National Committee on Uniform Traffic Control Devices

NCUTCD Proposal for Changes to the Manual on Uniform Traffic Control Devices

ITEM NUMBER: 18B-BIK-04

TOPIC: Bicyclist Rail/Flangeway Warning Sign

W10-X
18" x 24" or
24" x 30"

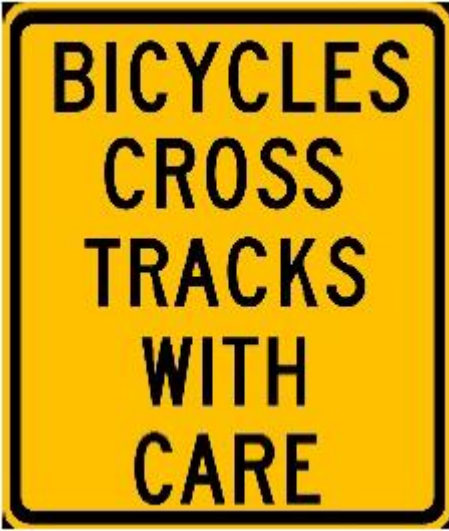
110 04 Where bicyclists cross or are riding adjacent to rail facilities, the BICYCLES CROSS
111 TRACKS WITH CARE (W10-XX) rectangular sign or plaque may be used.

113 05 The BICYCLES CROSS TRACKS WITH CARE (W10-XX) sign shall be a vertical
114 rectangle.

117 **The following new sign is added to Figure 9B-3**
